8 June 2018
Our Ref: 8774B.3KM(Panel)

**Re: DA-2016/358 – Response to Joint Regional Planning Panel Deferral
1-3 & 9 Canterbury Road, 638, 642 & 644-650 Northcliffe Drive, Kembla Grange**

Amended Clause 4.6 Variation Statement – Height of Buildings

Proposed Hardware and Building Supplies Development and Roadworks

Figure 1 Extract from the Architectural Section showing the location of the maximum building height of 16.6 metres

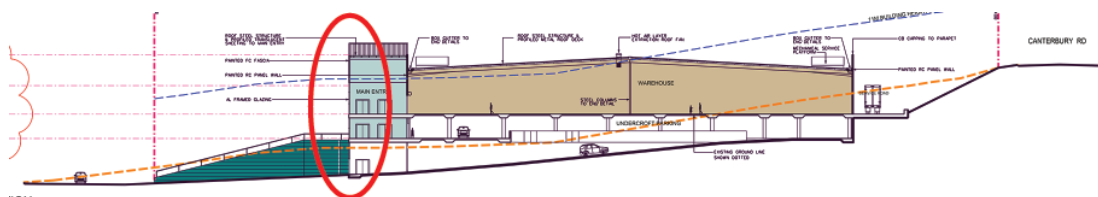
The proposed hardware and building supplies building has a maximum height of 16.6 metres at the ridge to the main pedestrian entrance on the southern elevation (see **Figure 1**). Elsewhere, the height ranges from approximately 10.3-15.8 metres in height.

- Between 0-4.6 metres along the eastern elevation;
- Between 3.0-5.6 metres along the southern elevation, with the majority of this being the entry feature which is 23m wide, comprising approximately 10% of the southern facade;
- Between 0-4.6 metres along the western elevation; and
- Between 0-3.6 metres along the northern elevation;

It should be noted that this amended DA, including shifting the building to a flatter part of the site, reduces the extent of the building height non-compliance. The original DA had a maximum building height of 18.2 metres whereas the amended proposal includes a maximum building height of 16.6 metres. Therefore, the maximum building height has been reduced by 1.6 metres.

Figure 2: Extract of Solar Analysis by JRB

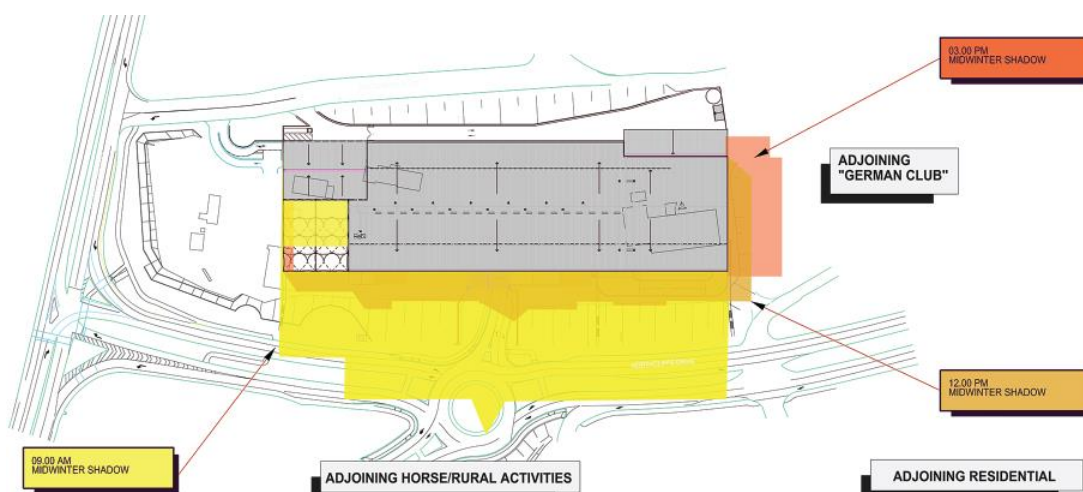
adverse impacts in terms of views of the sky from public areas or exposure of public or private spaces to sunlight. The latter is clearly demonstrated in the shadow analysis prepared by JRB see **Figure 2** which shows that whilst the proposed building will overshadow a small part of the expansive road reservation of Northcliffe Drive at 9am at midwinter, this will dissipate to no overshadowing of the road reservation at midday at midwinter. Furthermore, only a small area of the German Club land at 636a Northcliffe Drive will be overshadowed in the late afternoon at midwinter and no surrounding residential development will be overshadowed.
